**Rezoning Application:** PD 26-0349  
**Zoning Hearing Master Date:** April 27, 2026  
**BOCC Land Use Meeting Date:** June 9, 2026

This is a request to rezone a site from a Planned Development (PD) to a new Planned Development in order to add approximately 13.1 acres into the project. The request also seeks to make changes to the internal roadways and some amendments to conditions implemented by the Transportation Department. The number of approved residential units will remain unchanged.

**AGENCY REVIEW COMMENT SHEET**

### TYPICAL SECTION SEGMENT A SAFFOLD ROAD

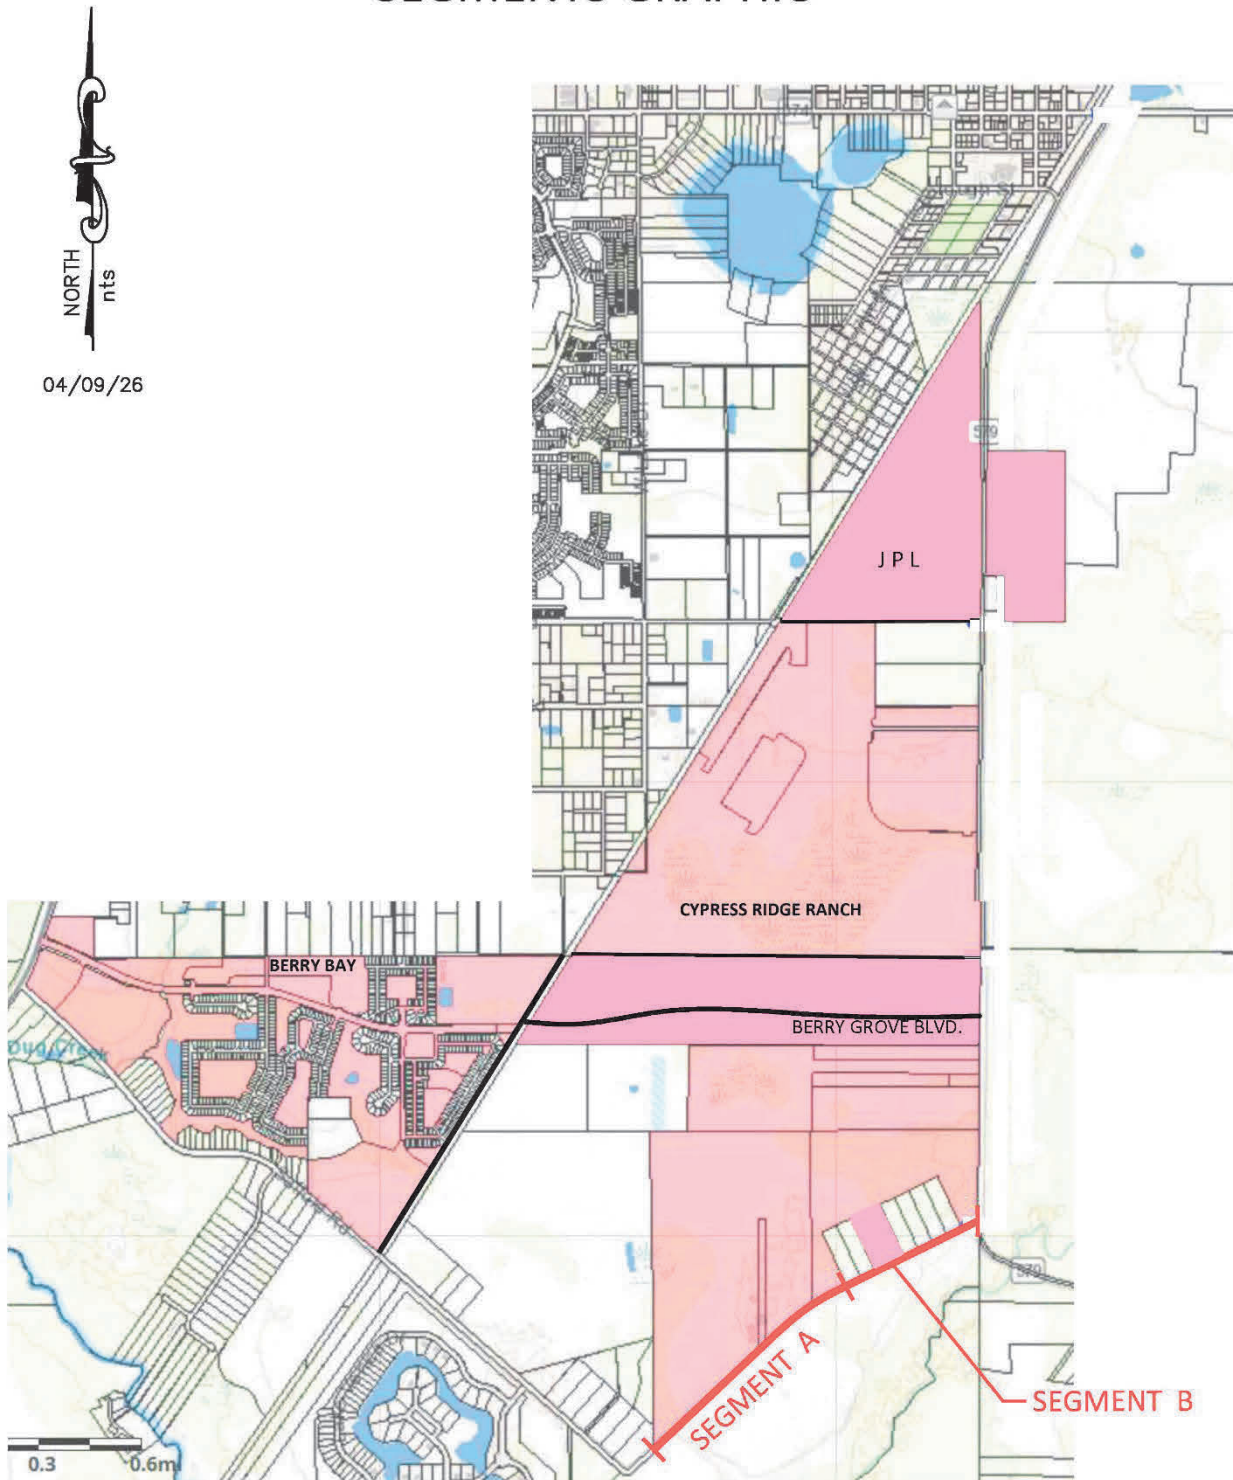
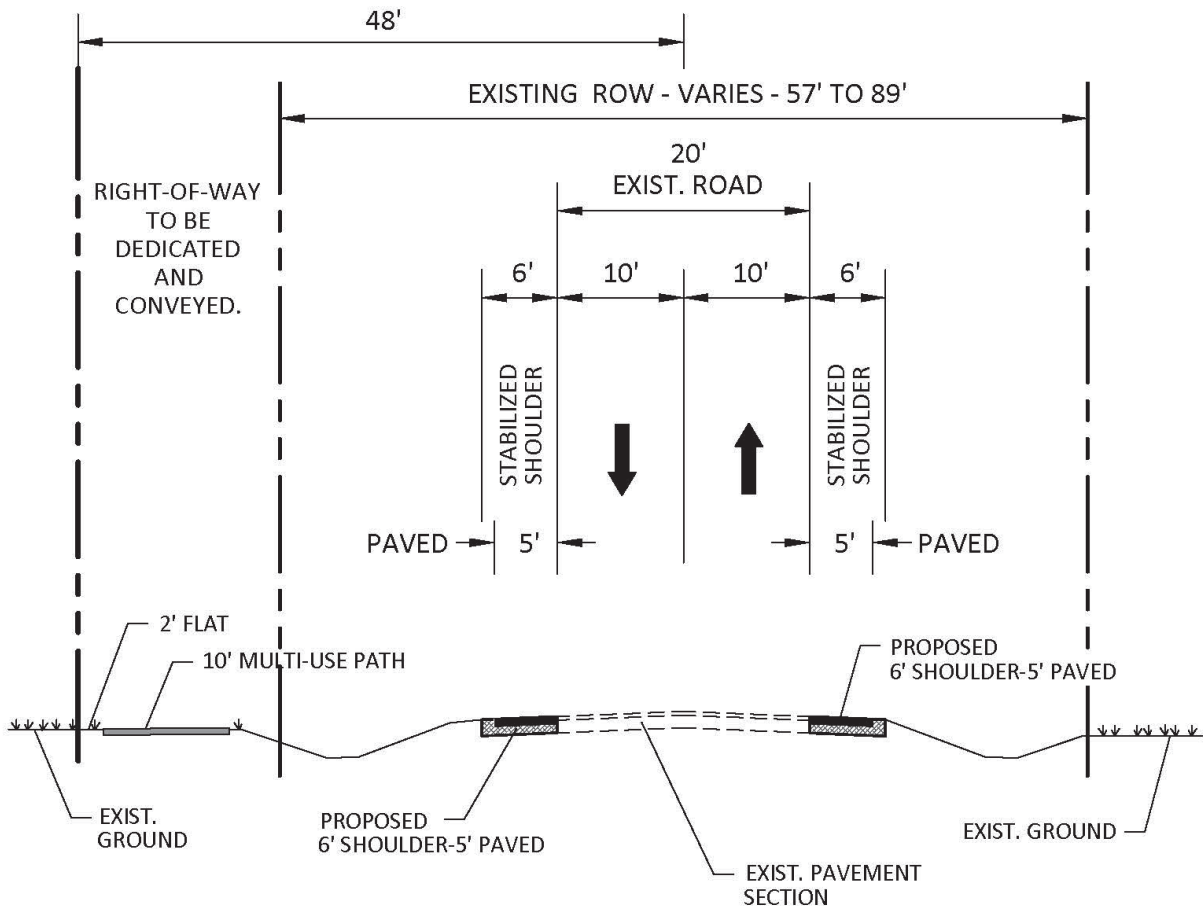
1. Right of Way – TS-7 has 96 feet of right of way. The right of way along the segment of Saffold Road varies between 71 feet to 89 feet. The developer will dedicate and convey the right of way required to provide improvements shown in Typical Section A or a total of 48 feet from the center line of the right of way, whichever is greater.
2. Lane Width – TS-7 has 12 foot lanes. The proposed section is to maintain the existing lanes at 10 feet. Due to limited right of way, 12 foot lanes cannot be provided.
3. Shoulder – TS-7 has 8 foot shoulders with 5 feet paved. The proposed section has 6 foot stabilized shoulder.

- 4. Sidewalk – TS-7 has 5 foot sidewalk on both sides of the roadway. A 5 foot sidewalk is proposed along the north side of Saffold Road.

# SEGMENTS GRAPHIC

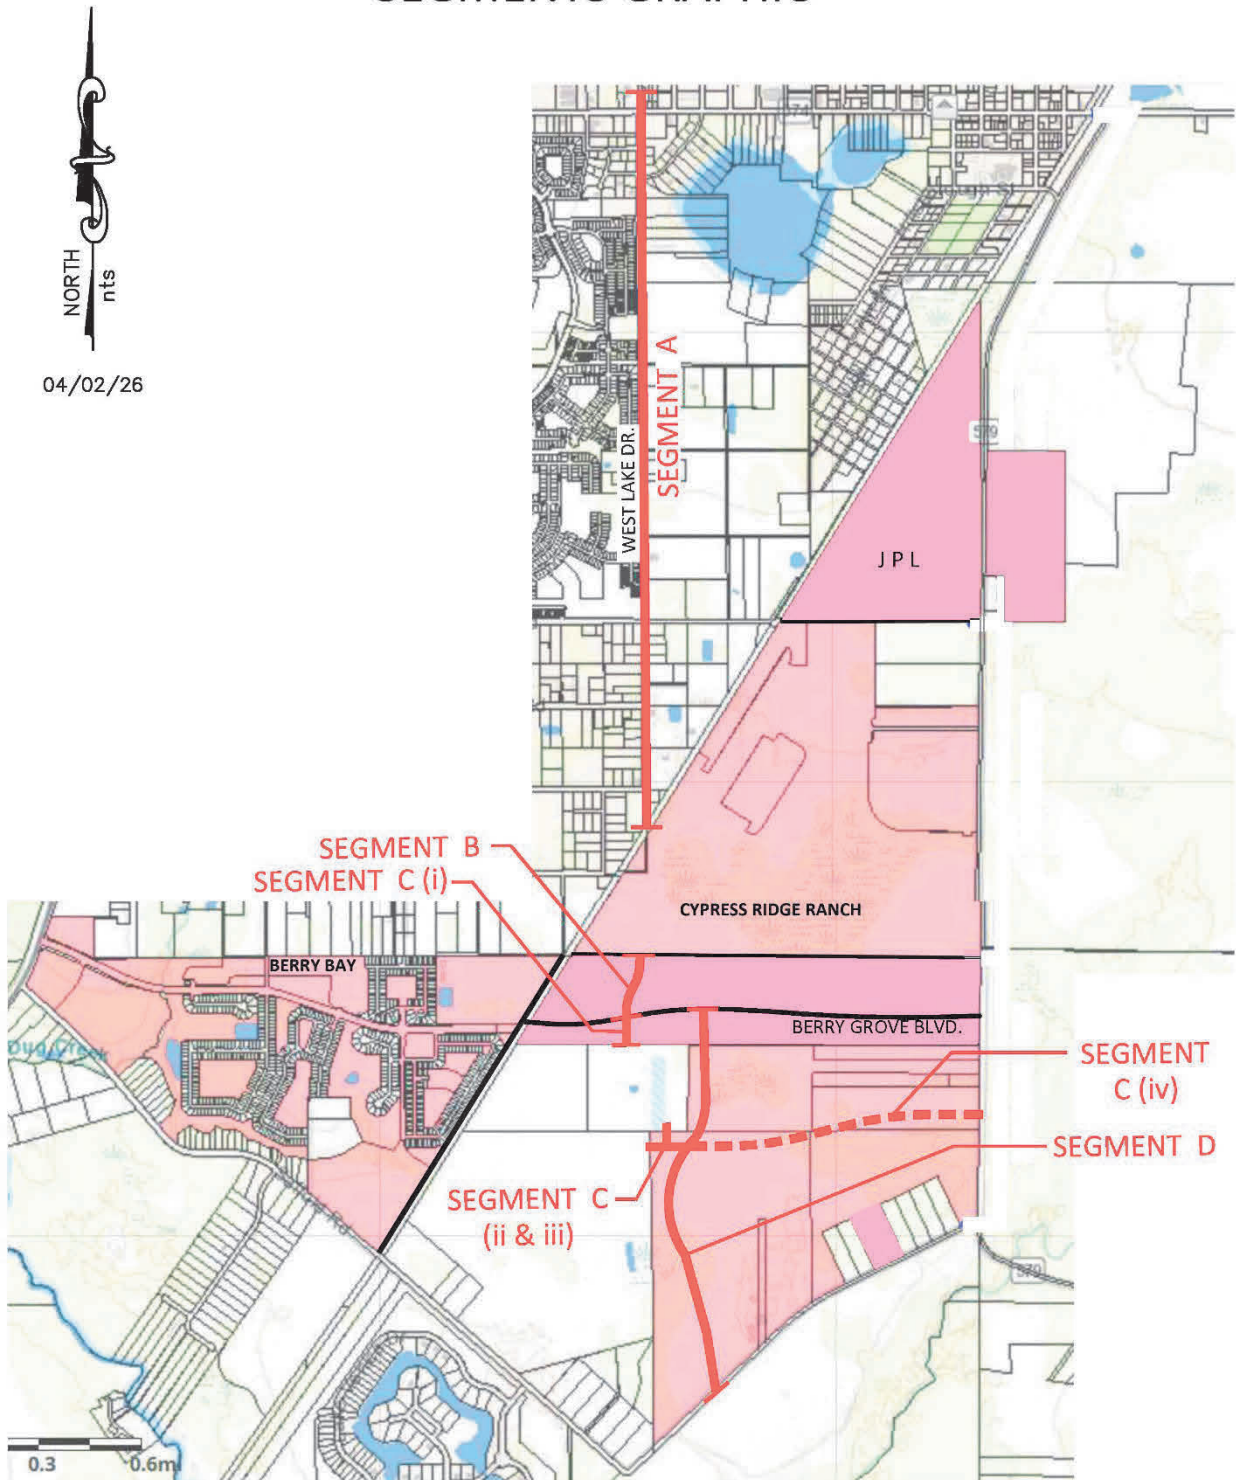
1. Bike Lanes – To match the typical section north of Bishop Road, 10 foot sidewalks are proposed on each side of the roadway in lieu of the bike lanes. From a safety standpoint, the 10 foot sidewalks provide a better option for students walking and riding bikes to school than students riding bikes within the roadway or pedestrian and bikes on a 5 foot sidewalk.
2. Sidewalk – 10 foot sidewalk on both sides of the roadway are proposed instead of the bike lanes. As stated above, given the roadway will serve the three (3) schools, the 10 foot sidewalks provide a better option for the school students.

1. Within Segment A, the developer shall widen/construct the roadway consistent with the TS-4 Typical Section, except that instead of the 5-foot sidewalks and 7-foot buffered bicycle lanes required per TS-4 the developer shall be permitted to install 10-foot-wide asphalt paths along both sides of the roadway. Additionally, the developer shall be permitted to reduce the required asphalt path separation as outlined below. The developer has proposed two typical sections for this segment (A-1 and A-2). Typical Section A-2 is the section where right-of-way is limited and/or there are design constraints. Use of Typical Section A-2 shall be minimized to the greatest extent feasible. The developer shall be permitted to reduce the required asphalt path separation between the closest edge of the asphalt path and the travel lane from 14-feet to 7-feet (for Typical Section A-1) and from 14-feet to 2-feet (for Typical Section A-2).

2. Within Segment B, the developer shall construct the roadway consistent with the TS-4 Typical Section, except that instead of the 5-foot sidewalks and 7-foot buffered bicycle lanes required per TS-4 the developer shall be permitted to install 10-foot-wide sidewalks along both sides of the roadway. Additionally, the developer shall be permitted to reduce the required sidewalk separation between the closest edge of the sidewalk and the travel lane from 14-feet to 6-feet. The developer shall also be permitted to eliminate the required 2-foot pedestrian clearance area between the back of sidewalk and edge of right-of-way.
